RE: Integrated Shoreline Public Access and Trail Plan – **Proposal #3 Pedestrian Connection to Waterfront West end**

Re: Stevenson Shoreline Access & Trails Plan

Thanks for submitting deliverable DT3.1, the *Draft Integrated Shoreline Public Access & Trail Plan*. I've reviewed the document, and other related work products, and gathered input from my in-house Technical Review Team. The project has made significant progress in considering local shoreline public access. Because individual draft chapters/components of the Plan were not available for review during development, this is our first look and our feedback includes both high-level issues and more detailed suggestions.

In addition to the Key Concerns identified in our 6/12/23 email (re: WAC Planning Process; Appraisal & Acquisition; SMP Amendment; and Ecological Functions) please also consider the following more detailed input:

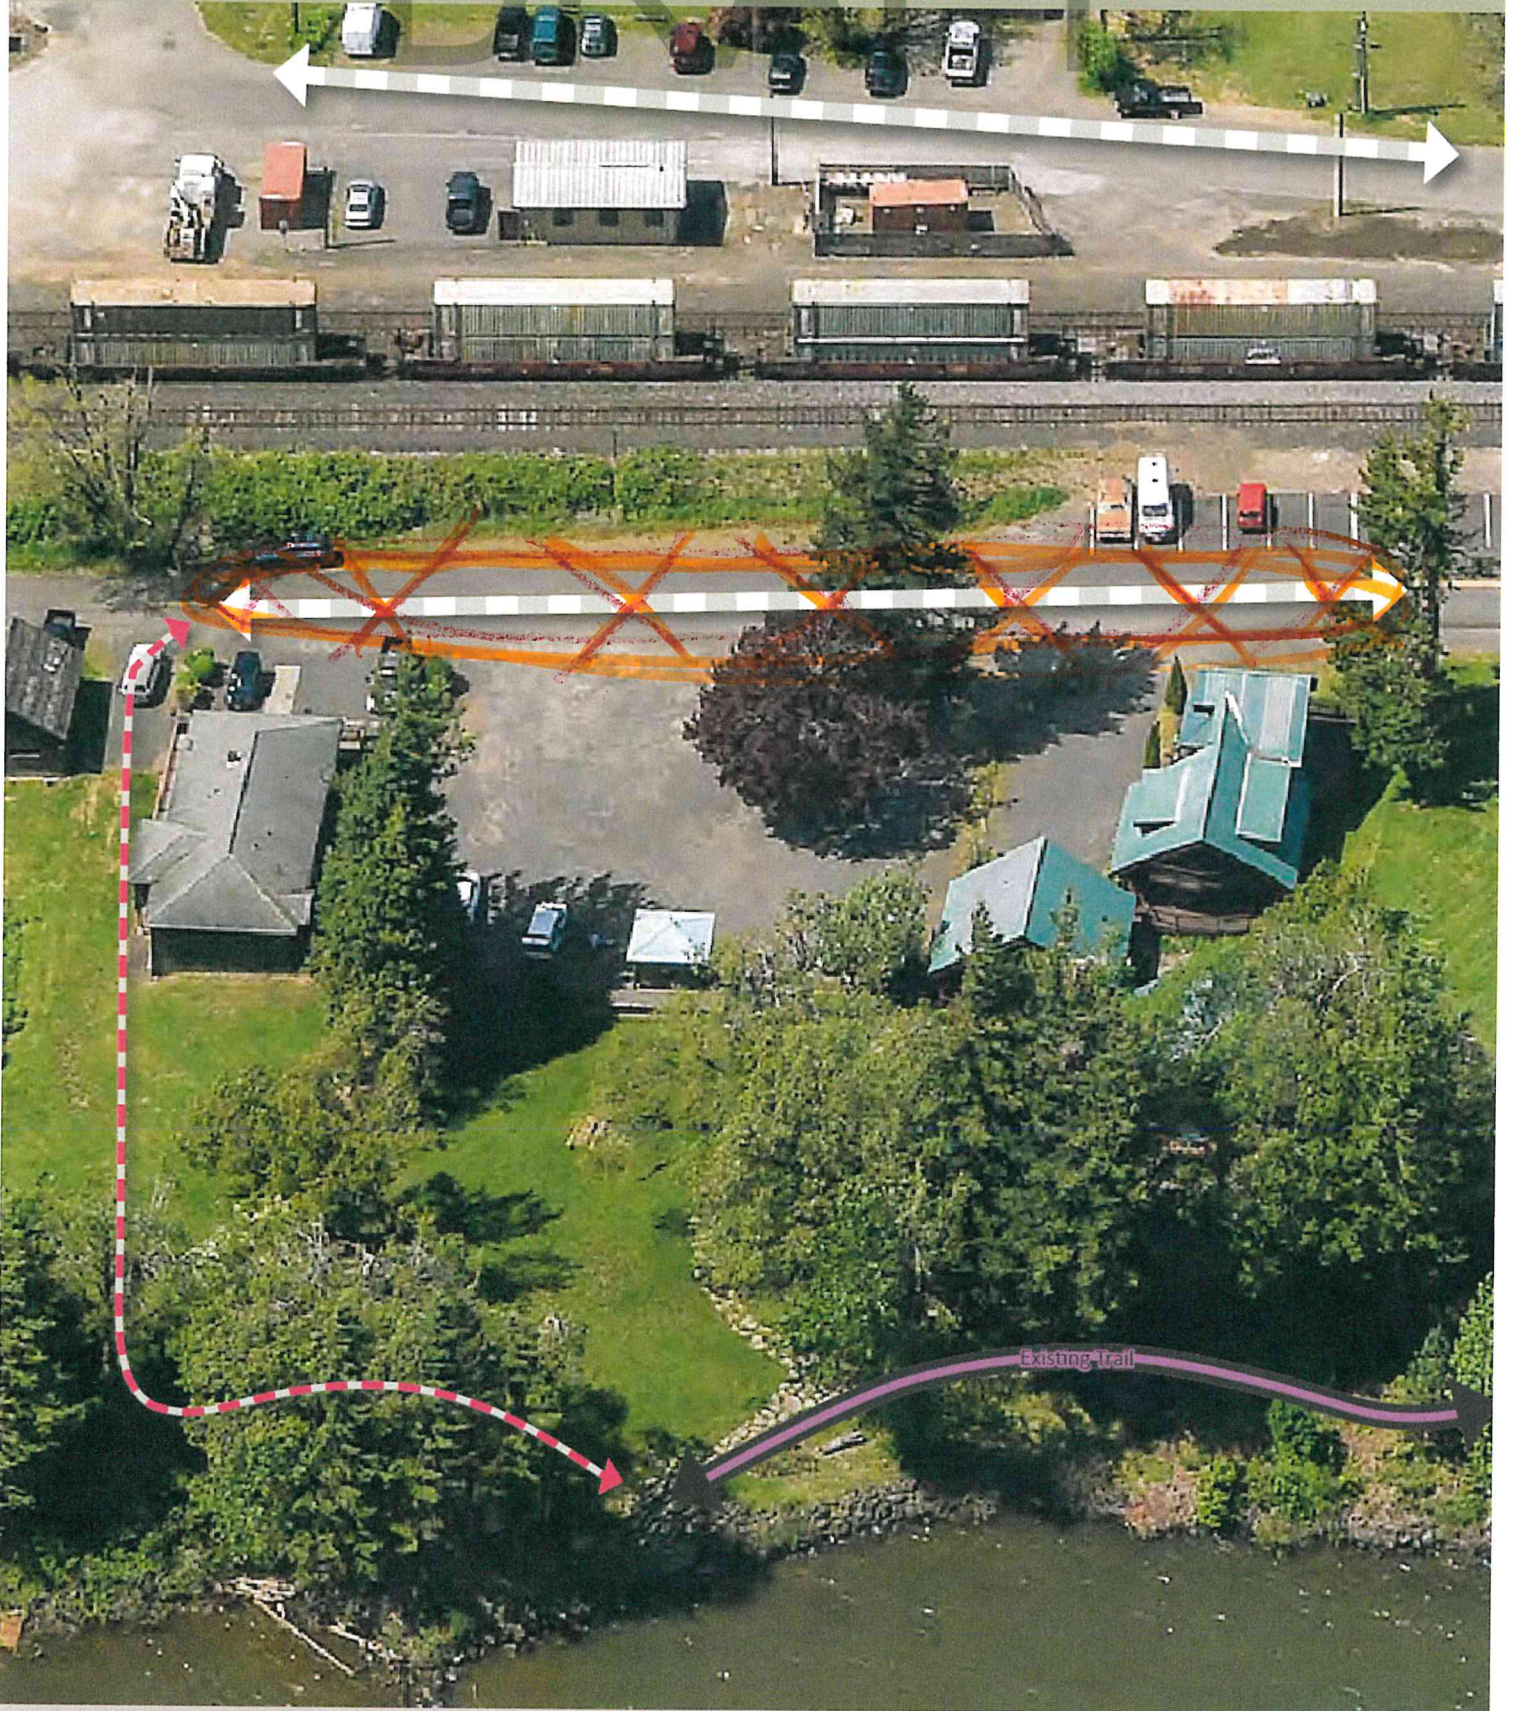
The Port would like to reiterate our opposition to the proposed sidewalk along Cascade Avenue from the Port Office, in front of Bob's Beach parking lot, and to Teo Park. This area is extremely busy and would negatively impact waterfront access to the large crowds of people who already use the area.

There has been a steady stream of Bob's Beach regulars coming in to express concerns about a proposed section of Cascade Avenue sidewalk (see attached). The Port agrees with their assessment that a sidewalk from Teo Park has little value and would impede traffic flow and reduce parking. Please consider this the Port's opposition to that specific idea within the draft plan.

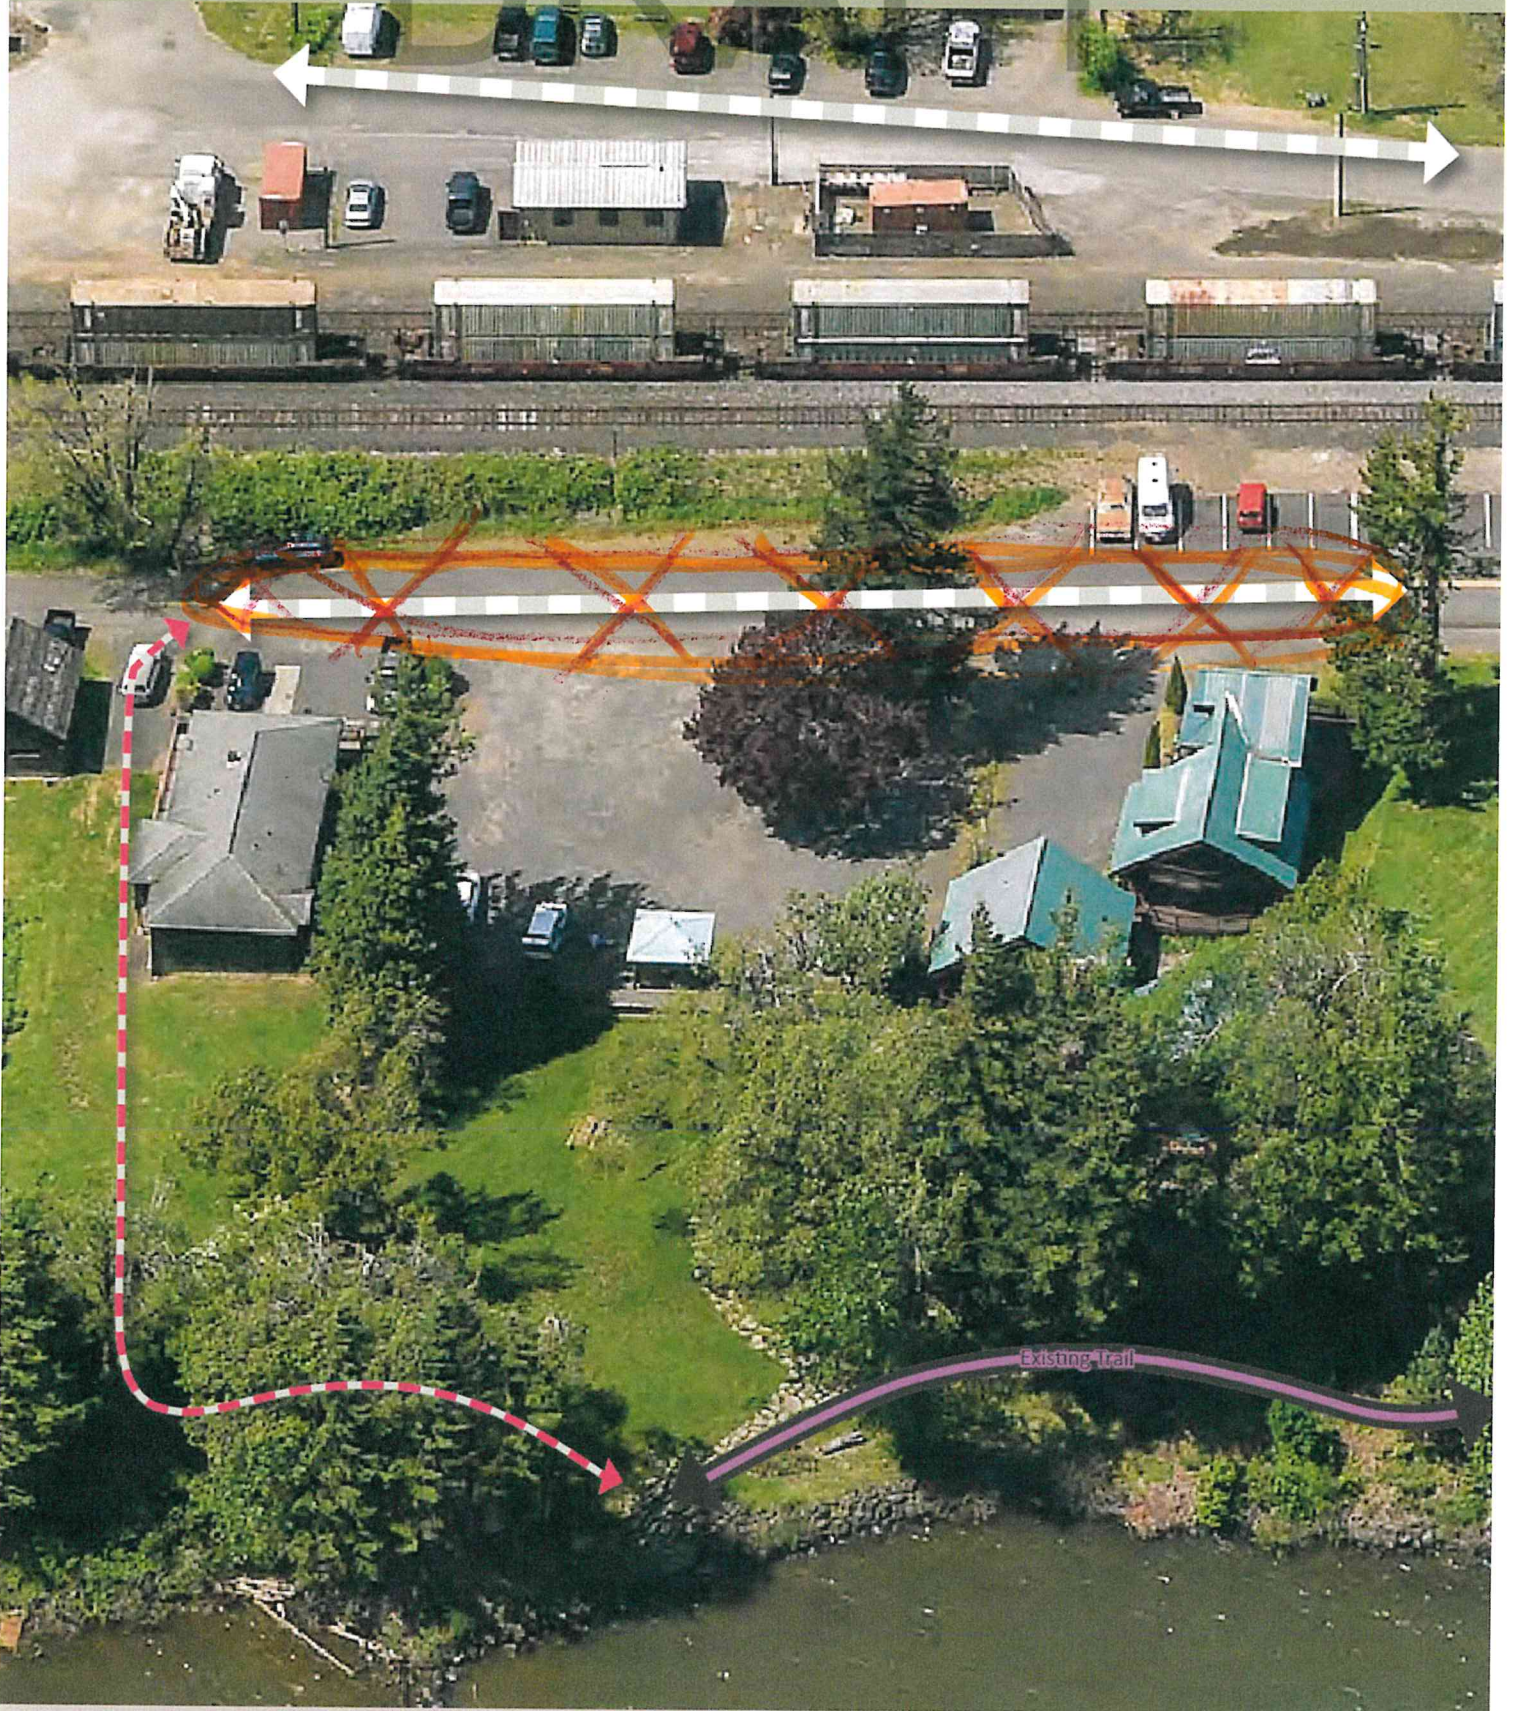
There has been a steady stream of Bob's Beach regulars coming in to express concerns about a proposed section of Cascade Avenue sidewalk (see attached). The Port agrees with their assessment that a sidewalk from Teo Park has little value and would impede traffic flow and reduce parking. Please consider this the Port's opposition to that specific idea within the draft plan.
